UNITED STATES PATENT AND TRADEMARK OFFICE

| APPLICATION NO. | FILING DATE | FIRST NAMED INVENTOR | ATTORNEY DOCKET NO. | CONFIRMATION NO. |
|-----------------|-------------|----------------------|---------------------|------------------|
| 09/398,652 | 09/17/1999 | WILLIAM A. SAMARAS | 042390.P5120D | 1359 |

| Office Action Summary | Application No. 09/398,652 | Applicant(s) SAMARAS ET AL. ad | |

DETAILED ACTION

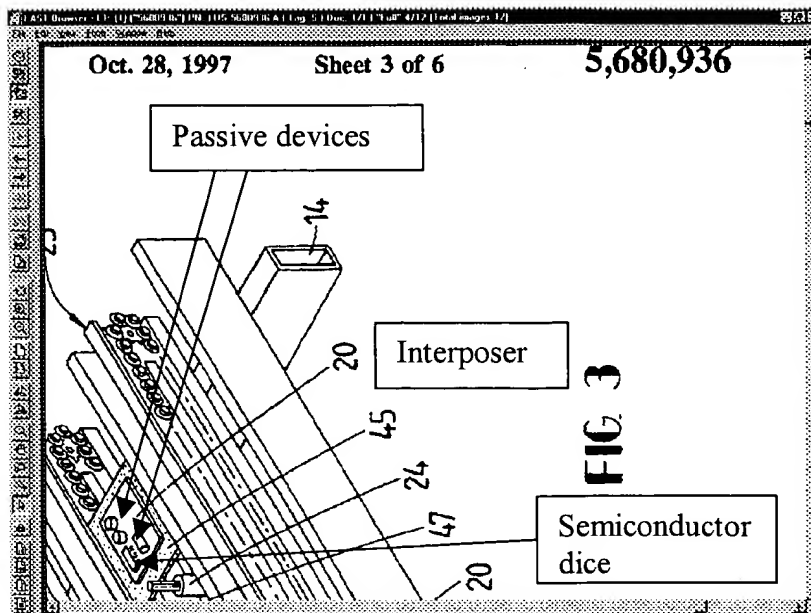
Beers discloses coupling at least one passive device (see annotated Fig. 3 below) thereby regulating voltage and current to the electronic dice.

Furthermore, it would have been obvious to one of ordinary skill in the art at the time the invention was made to modify Seidel by coupling at least one passive device to the first surface of the interposer, as taught by Beers, for the purpose of regulating voltage and current to the electronic chip.
